FINAL PLAT OF
"DOWNS' COUNTRY ESTATES"
SEDGWICK COUNTY, KANSAS
IN THE SE 1/4 OF SECTION 17, T28S, R2E OF THE 6TH P.M.

RE: SUB 2000-84 -- Final Plat of DOWNS' COUNTRY ESTATES ADDITION

CASE NUMBER: SUB 2000-84 – DOWNS COUNTRY ESTATES

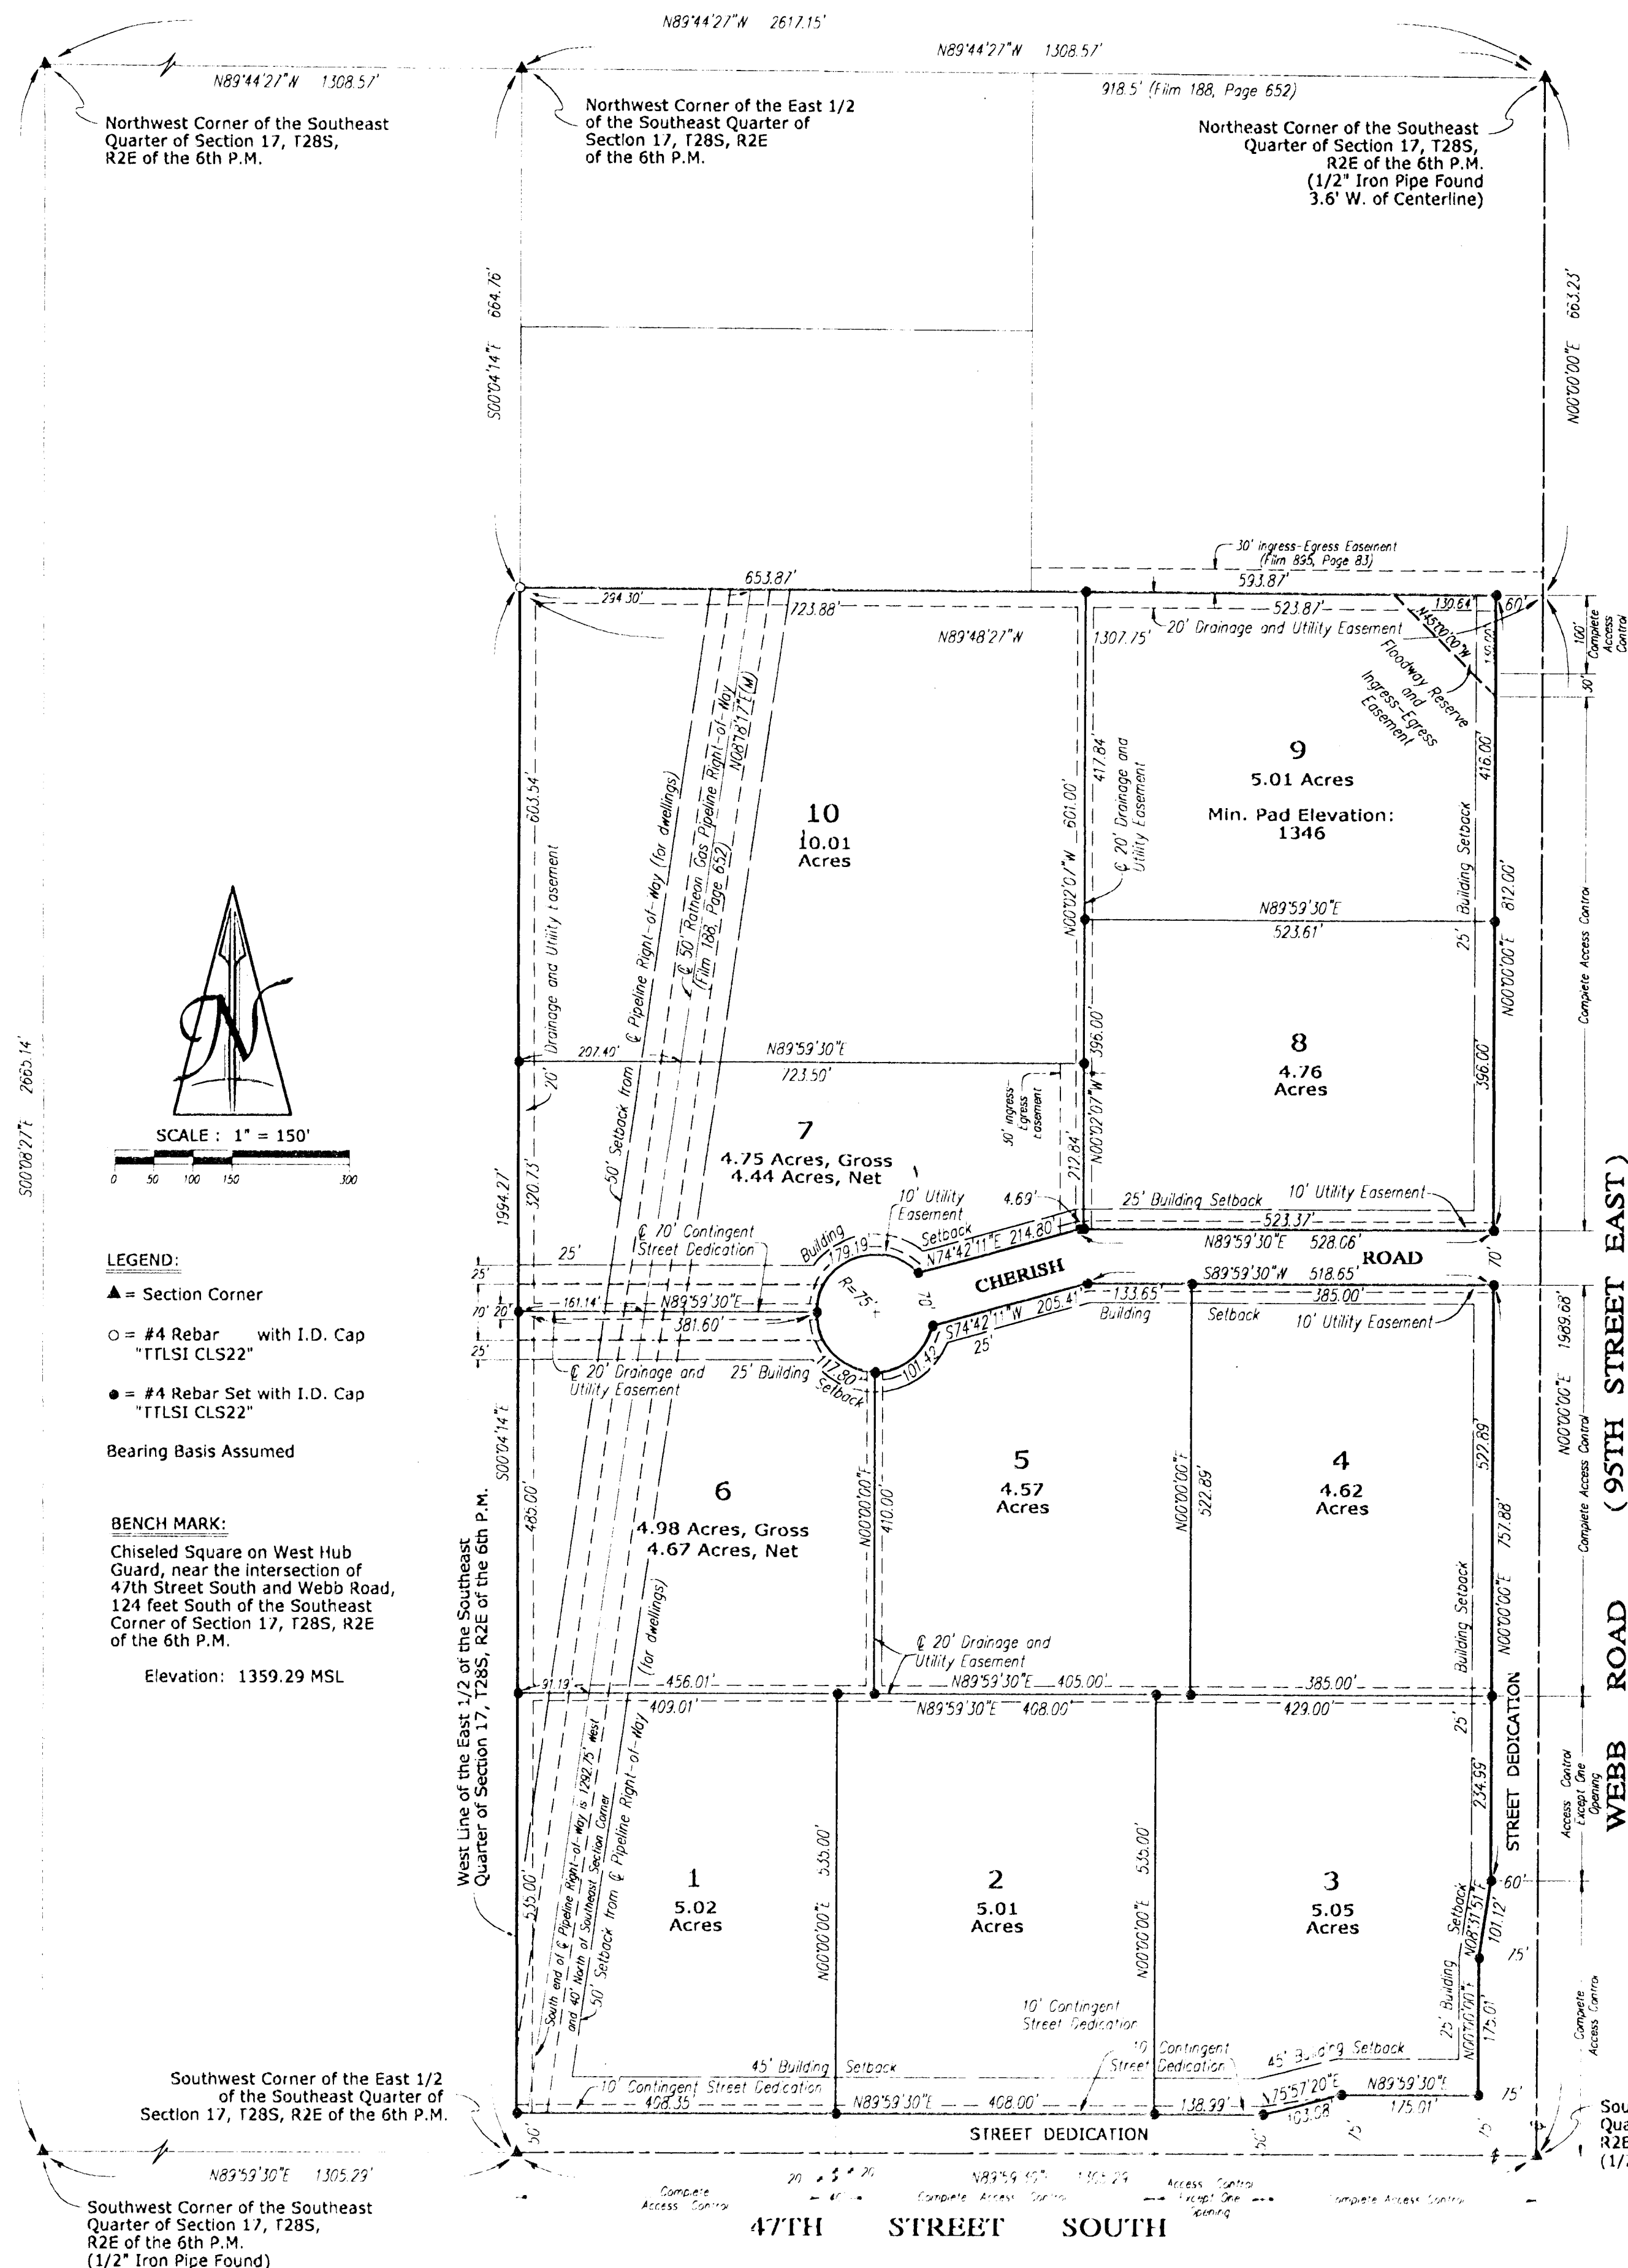
- C. County Engineering needs to comment on the status of the applicant's drainage plan. The drainage plan is approved. The minimum pad elevation for Lot 9 should be revised to read "1346".

- D. The final plat shall reference the access controls in the plat's text. The Subdivision Committee approved a shared opening between Lots 1 and 2, which shall be 40-feet wide. Lots 4 and 8 shall have access from the internal street. Lot 10 shall have access through a 20-ft private road extending through Lot 9 or Lot 7.

- F. The ingress-egress easements located in Lot 7 and Lot 9 shall be established by separate instrument. Initial construction responsibilities and future maintenance of the driveway within the easements should also be addressed by the text of the instrument.

- I. County Engineering has required a 10-ft contingent right-of-way along 47th St. South.
- J. The applicant shall submit a copy of the instrument which establishes the pipeline easements on the property, which verifies that the easements shown are sufficient and that utilities may be located adjacent to and within the easements.

- K. The applicant's agent shall determine any setback requirements for the pipelines by researching the text of the pipeline agreements. If a setback from the pipeline easements is provided for in the pipeline easement agreements, it shall be indicated on the face of the plat.

- X. The representatives from the utility companies should be prepared to comment on the need for any additional utility easements to be platted on this property. KGE has requested additional easements.
